Date of Issue: October 2007

Affected Publication: API Recommended Practice 2A-WSD, *Recommended Practice for Planning, Designing and Constructing Fixed Offshore Platforms—Working Stress Design*, Twenty-first Edition, December 2000

ERRATA AND SUPPLEMENT 3

Figure 4.2-2, see revised figure.

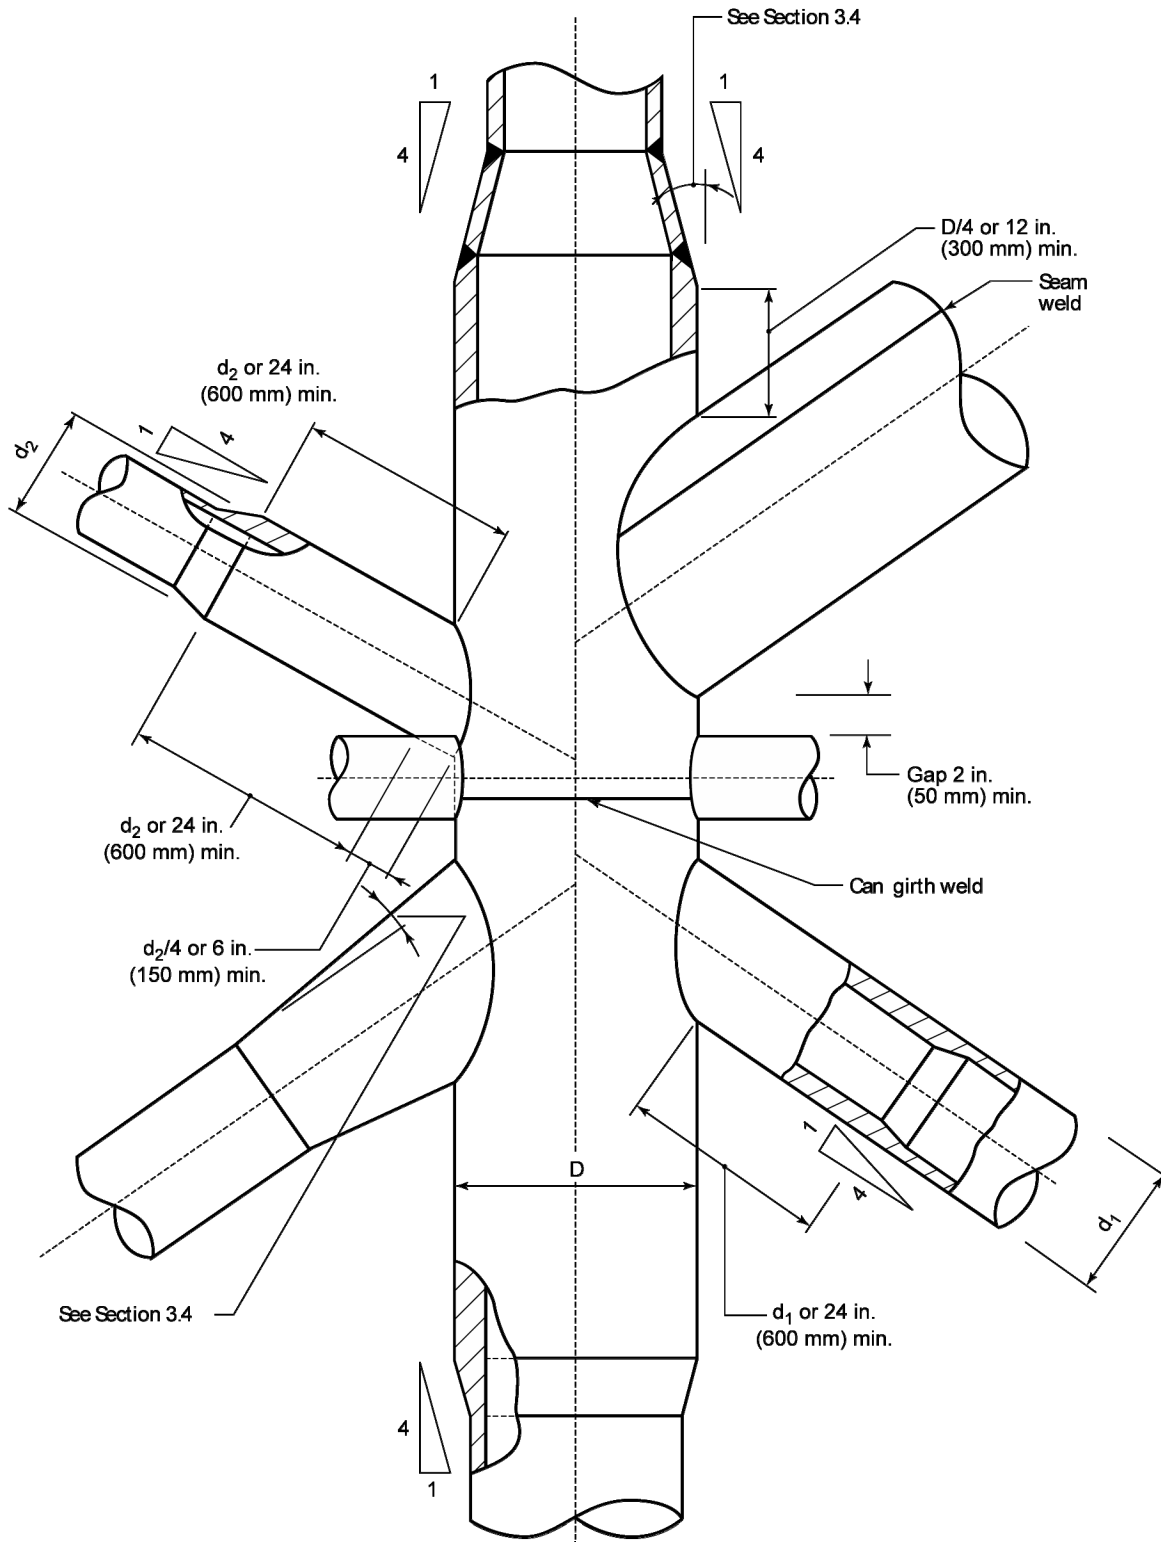
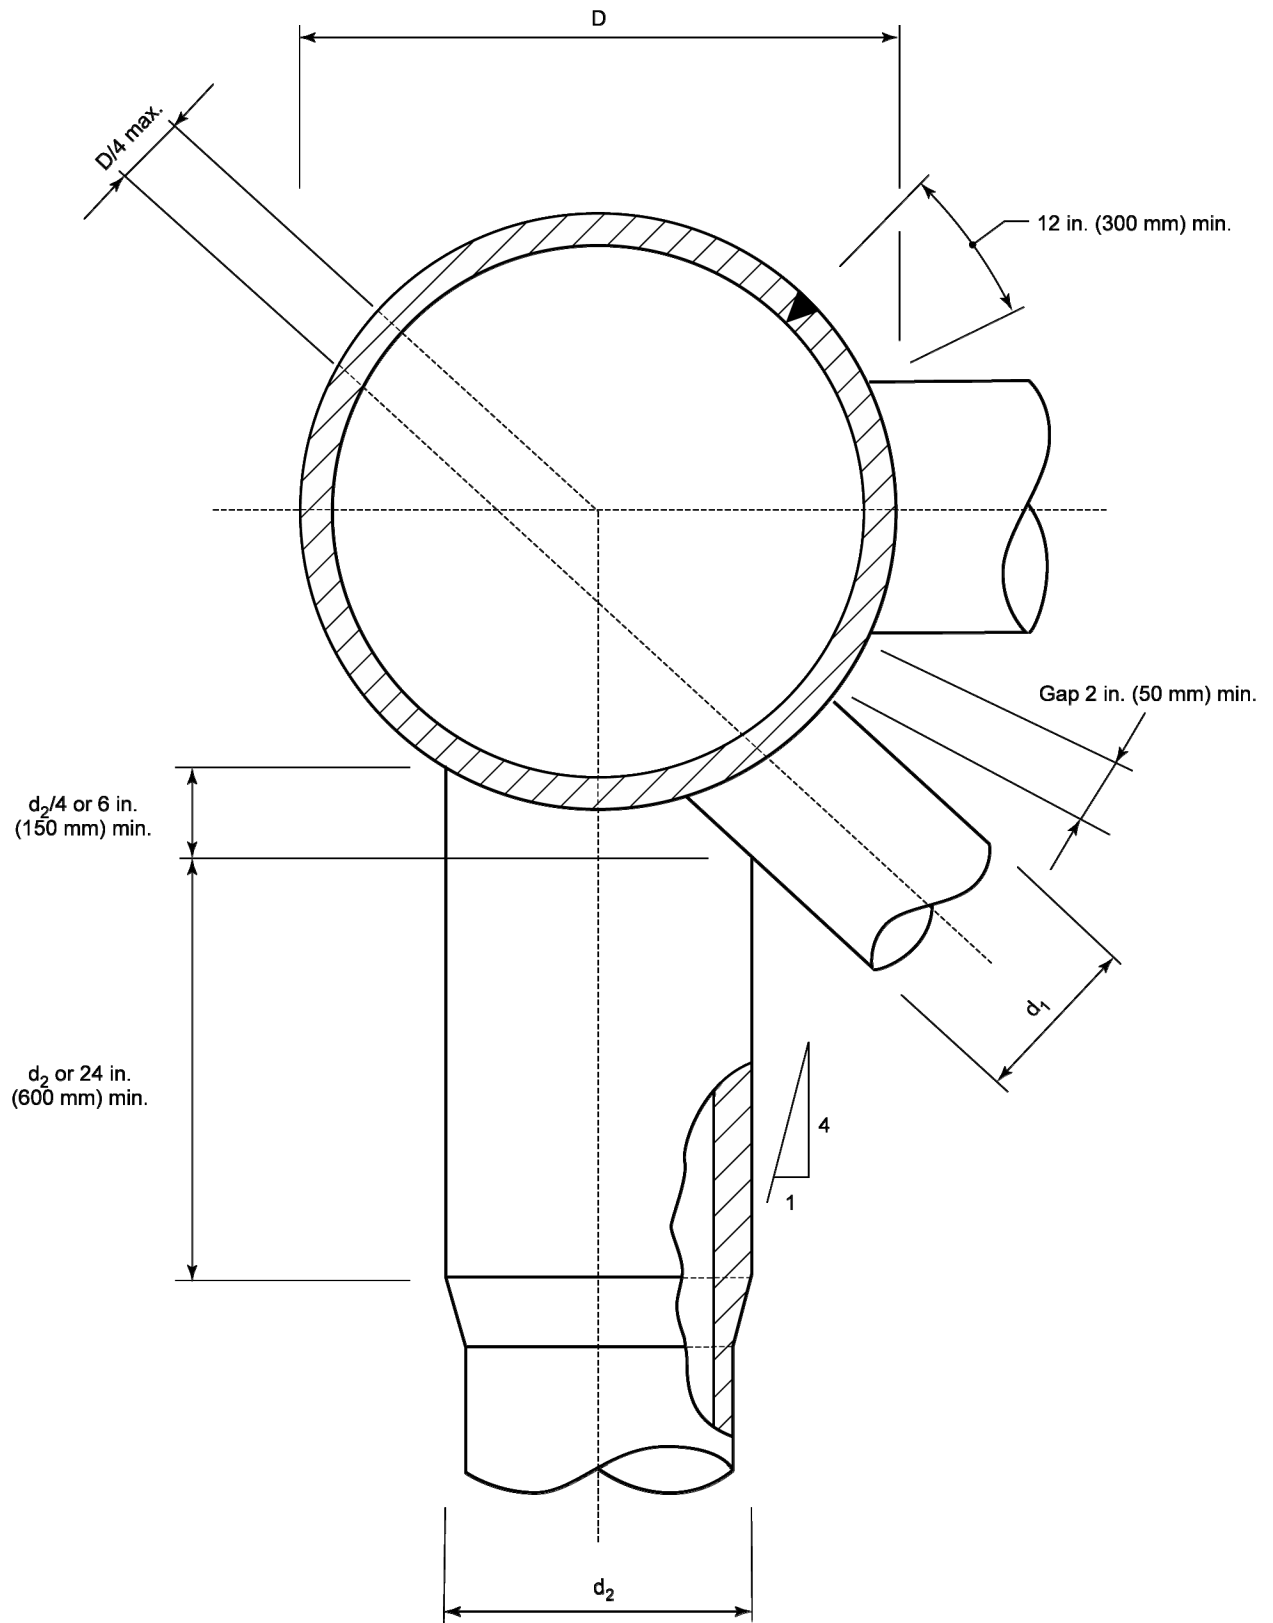
Figure 4.2-3, see revised figure, replace:

“6 in.” dimension in the upper right corner with “12 in. (300 mm) min.”

Figure C4.2-1—Adverse Load Patterns with α Up to 3.8 (a) False Leg Termination, (b) Skirt Pile Bracing, (c) Hub Connection

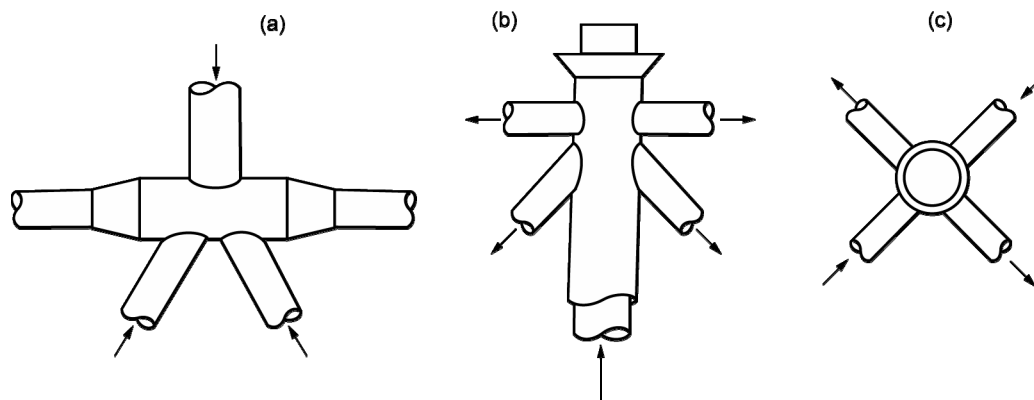
Insert new Figures C4.2-1 and C4.2-2
